Millstone Nuclear Power Station, Unit No. 3 Responses to SER Confirmatory Item

SER 15 - Thermal-Hydraulic Analyses to Support N-1 Loop Operation

Normalized flow distribution with four loops operating without the dummy instrumentation tubes.

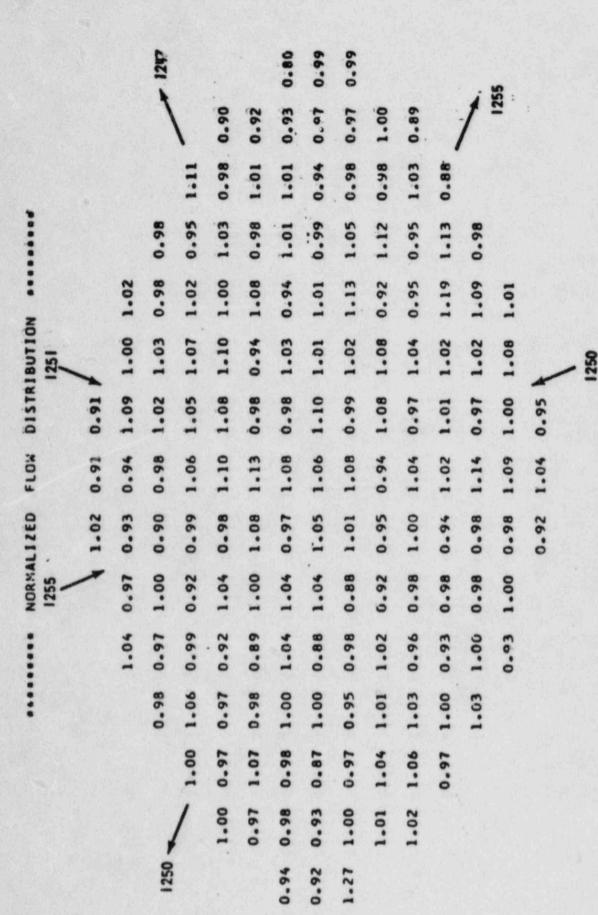
In a letter dated April 9, 1984, the applicant expressed the intent to operate in the N-1 mode. However, the applicant has not yet provided core thermal-hydraulic analyses taking into account the effect of partial loop operation on core inlet flow distribution and minimum DNBR or Technical Specifications including the appropriate provisions to ensure that this type of operation is within acceptable limits.

The core inlet flow distribution criteria used in the THINC analyses (DNBR evaluation) are based on 1/7 scale hydraulic reactor model tests (References I and 2). THINC analyses using this data have indicated that a conservative design basis is to consider a five percent (5%) reduction in the flow of the hot assembly. Studies made with the improved THINC model (Reference 3) show that it is appropriate to use the 5% reduction in inlet flow to the hot assembly for one loop out of service based on the experimental data in Reference I and 2.

The inlet flow distributions (from Ref. 2) for three and four loops in operation have been provided for comparison.
